PLANNING COMMISSION

-STAFF REPORT -

MLP 10-01
Minor Partition

TENTATIVE PARTITION PLAN
FOR
WHOLESALE REAL ESTATE LLC
228 N.E. 10TH AVENUE
THE WEST 1/2 FEET OF LOT 16, "CANBY ACRES"
LOCATED IN THE NW 1/4 OF SECTION 33, T36N, R12E, W11, IN THE CITY OF CANBY, CLACKAMAS COUNTY, OREGON

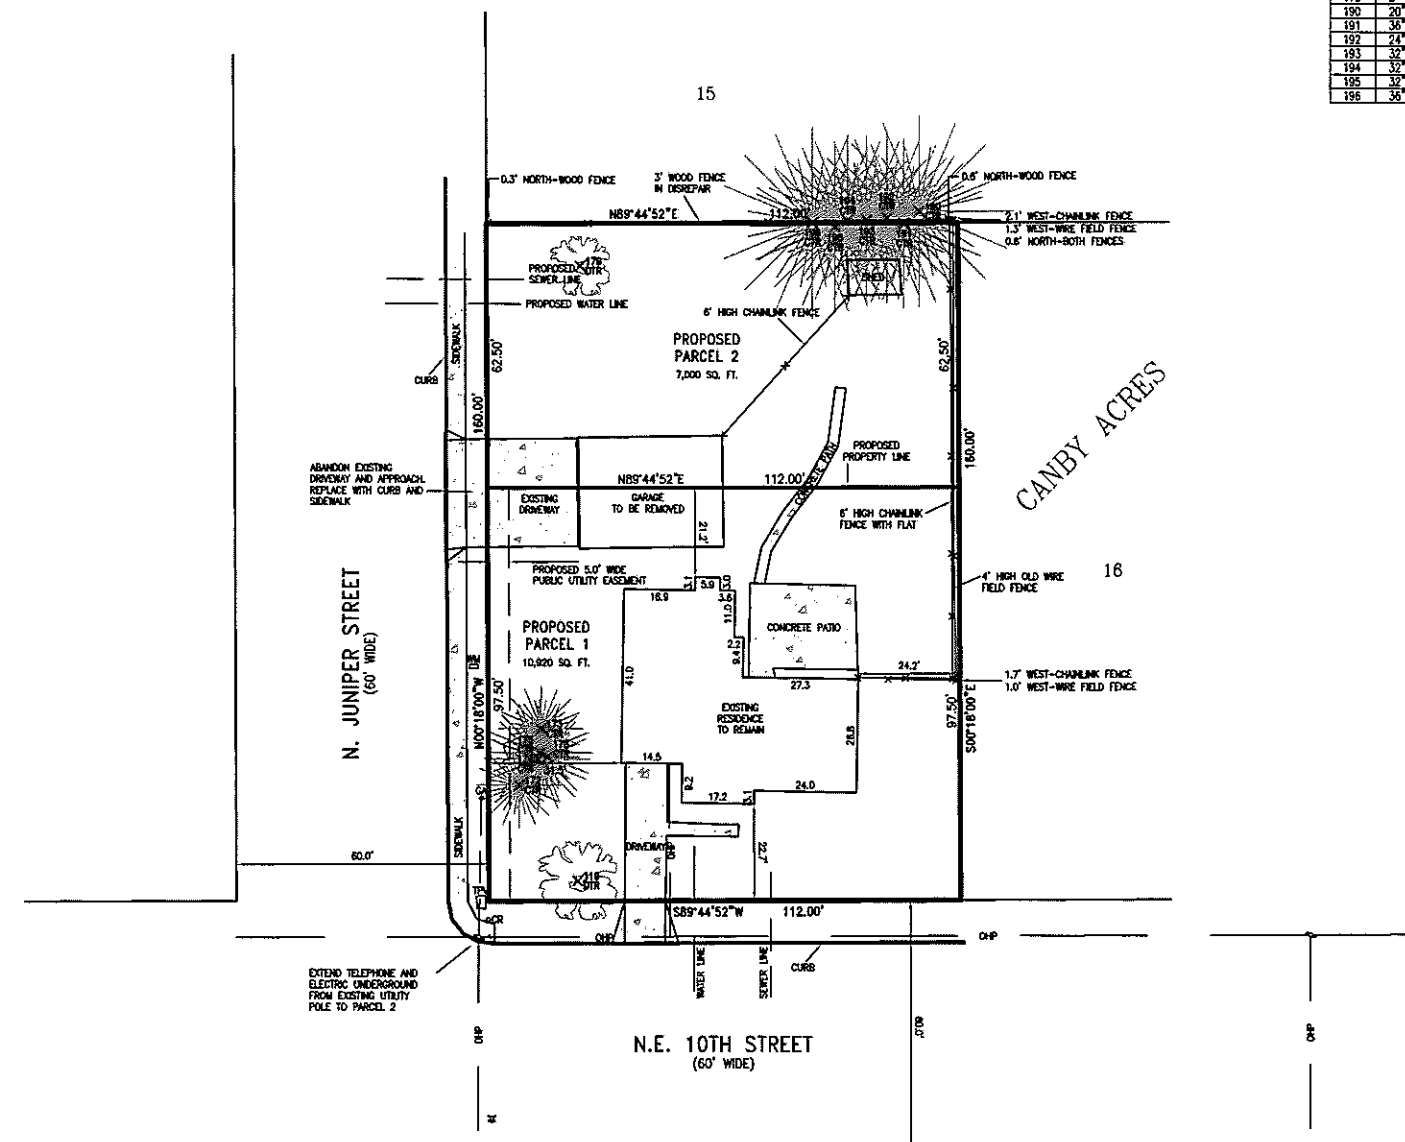
The applicant has agreed to the removal of the existing driveway onto Juniper Street which leads to the garage to be removed. The driveway approach within the right-of-way will be removed along with that portion on the private property and a new curb will be installed along with a sidewalk where the driveway is to be removed.

the exact location for a driveway approach for the new vacant parcel being created. This would be an added expense to whoever owns the lot and pulls a building permit in the future if not installed prior to filing the partition plat. The location of the driveway is only limited by a 30 foot separation from any existing driveway on adjacent lots. Staff finds that this is a reasonable request to delay this driveway approach installation until the time of the building permit when the house plan is known. This driveway installation will be made at the time of a building permit without adversely impacting adjacent properties and can comply with the necessary separation requirement.

Canby Public Works: Sanitary sewer is available along the Juniper Street frontage. The ditch line will need to be filled with C.D.F. resawed cut and patched with 1 6-inch service to new single family home or two service lines if a duplex. All storm water to be onsite, not to the street with development.

Consulting Engineer: Applicant will need to improve sidewalks to current ADA standards including driveway and curb return area.

1. Remove the existing detached garage as indicated prior to approval and filing of the partition plat.
2. Abandon and remove the existing driveway as indicated both on private property and the public street approach on Juniper Street and replace the curb and sidewalk prior to filing of the partition plat or with adequate performance assurance.

3. The future driveway installation to serve Parcel 2 must maintain a 30-foot minimum separation from the nearest adjacent driveway.
4. Dedicate a 5-foot wide public utility easement adjacent to the west boundary of Parcel 1 on the final partition plat to be recorded as indicated to allow the extension of underground electric and telephone service to Parcel 2.
